FOOTHILLS WATER NETWORK

December 20, 2010

**RE: COMMENTS ON PLACER COUNTY WATER AGENCY'S
DRAFT LICENSE APPLICATION FOR THE MIDDLE FORK AMERICAN
HYDROELECTRIC PROJECT #2079**

Figure O-15. Middle Fork American River MF14.1 Effective Food Production Habitat Matrix.

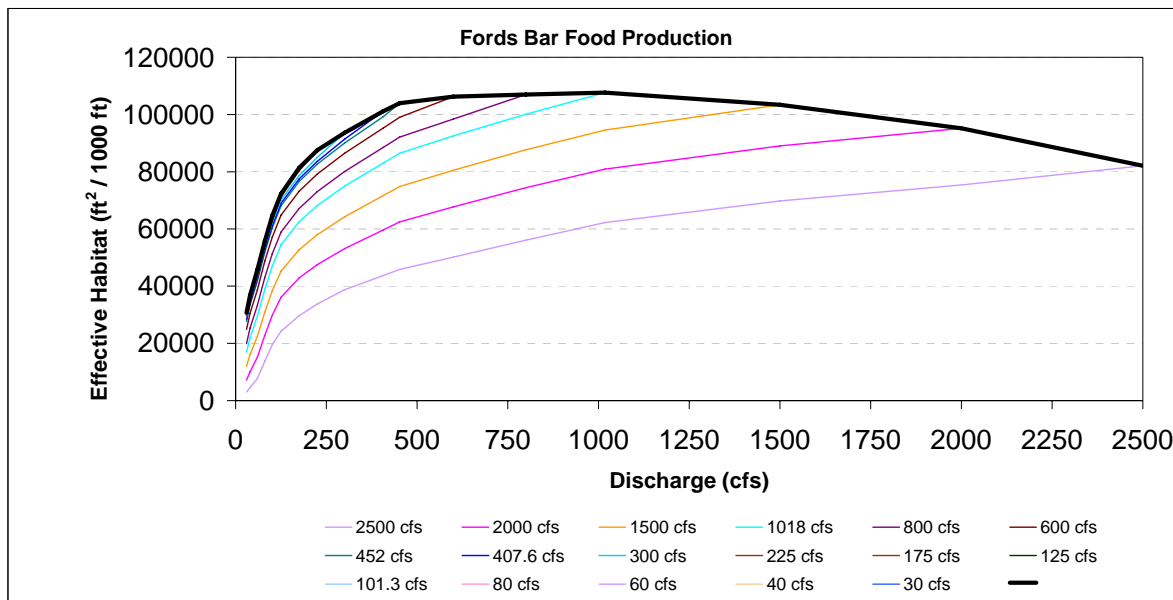
The Foothills Water Network recommends that PCWA include conditions in its FLA that reduce flow fluctuations in the Peaking Reach to increase benthic macroinvertebrates (BMI) populations and food production for fish. Based on PCWA's Effective Food Habitat Matrices for the Peaking Reach, food production increases as the magnitude of flow fluctuations decrease.¹⁰ (See Appendix C for AQ1-Instream Flow Study Report, Figure O-15 and O-24 Middle Fork American Effective Food Habitat Matrices.) An increase in minimum instream flows from the PCWA DLA proposed minimum flows would increase food production and BMI habitat in the Peaking Reach.
